NO.1

MODIFICATION WORK ORDER

MWO 9-2320-280-20-1

MODIFICATION OF 1-1/4 TON VEHICLES

FIGURE 1

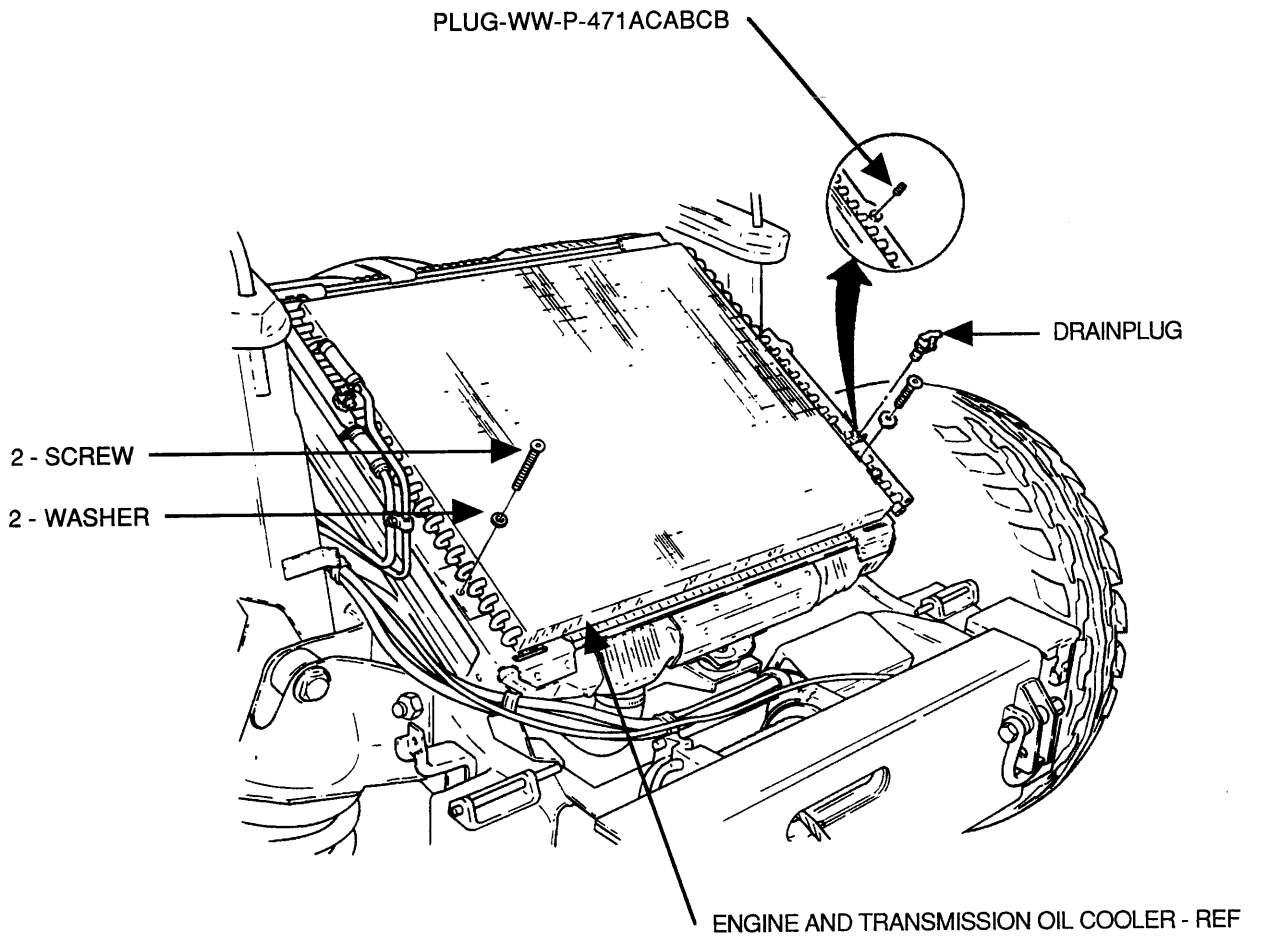
- (1) Disconnect battery ground cable. (Refer to TM 9-2320-280-20.)
- (2) Remove hood. (Refer to TM 9-2320-280-20.)
- (3) Remove left side splash shield. (Refer to TM 9-2320-280-20.)
- (4) Remove drainplug from oil cooler as shown in figure 1.

- (5) Install WW-P-471ACABCB plug in oil cooler as shown in figure 1.
- (6) Remove two lower screws and washers from oil cooler as shown in figure 1.
- (7) Remove two nuts, washers, screws, and clamps from power steering hoses as shown in figure 2. Save for installation.
- (8) Remove two clamps and hose from control valve elbow and steering gear as shown in figure 2. Save for installation.

FIGURE 3

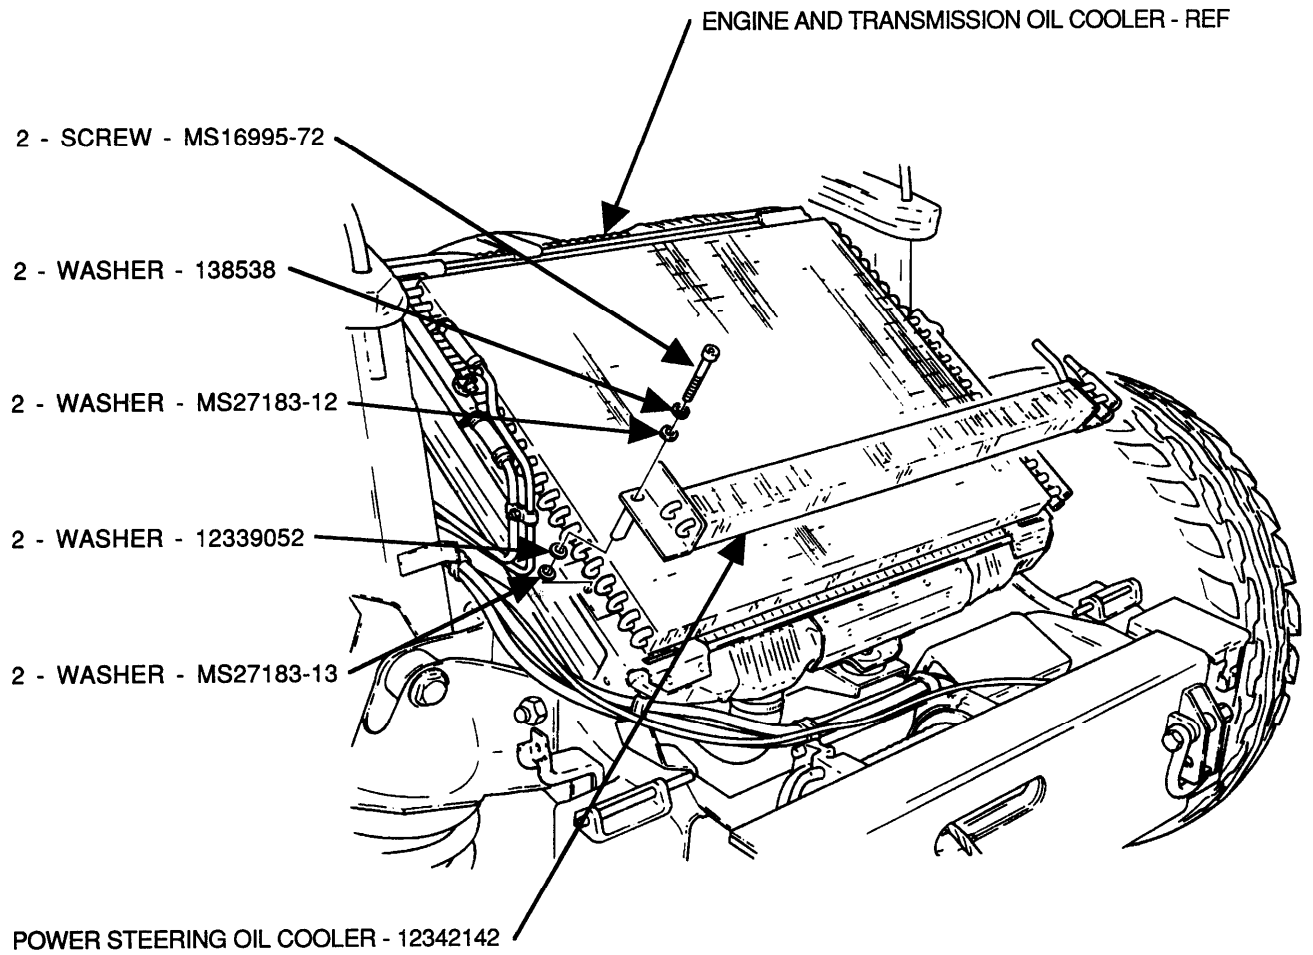
(1) Position two MS16995-72 screws, 138538 washers, and MS27183-12 washers to 12342142 power steering oil cooler as shown in figure 3.

(2) Position two 12339052 washers and MS27183-13 washers to oil cooler as shown in figure 3.

(3) Install power steering oil cooler to oil cooler and secure with two screws as shown in figure 3. Tighten screws to 12-14 lb-ft (14-18 N m).

FIGURE 4

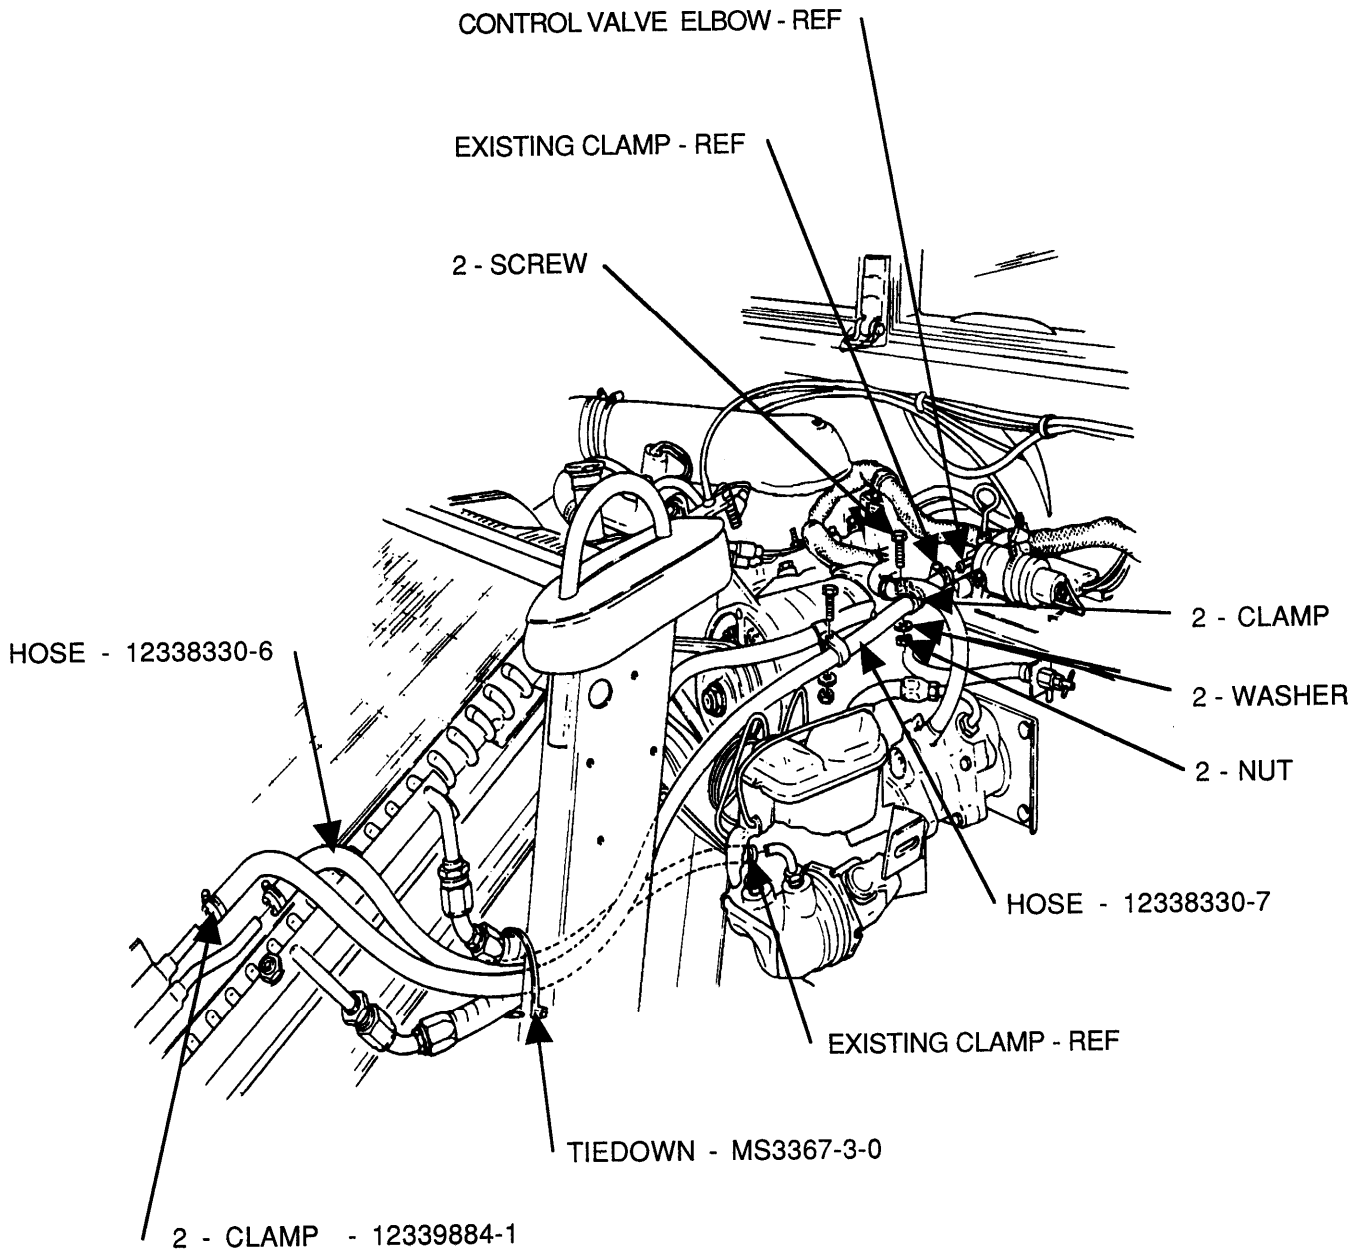
(4) Install 12338330-6 hose to power steering oil cooler and power steering gear and secure with 12339884-1 clamp and existing clamp as shown in figure 4.

(5) Install 12338330-7 hose to power steering oil cooler and control valve elbow and secure with 12339884-1 clamp and existing clamp as shown in figure 4.

(6) Position two existing clamps on hose and secure with two screws, washers, and nuts as shown in figure 4.

(7) Secure hoses with MS3367-3-0 tiedown as shown in figure 4.
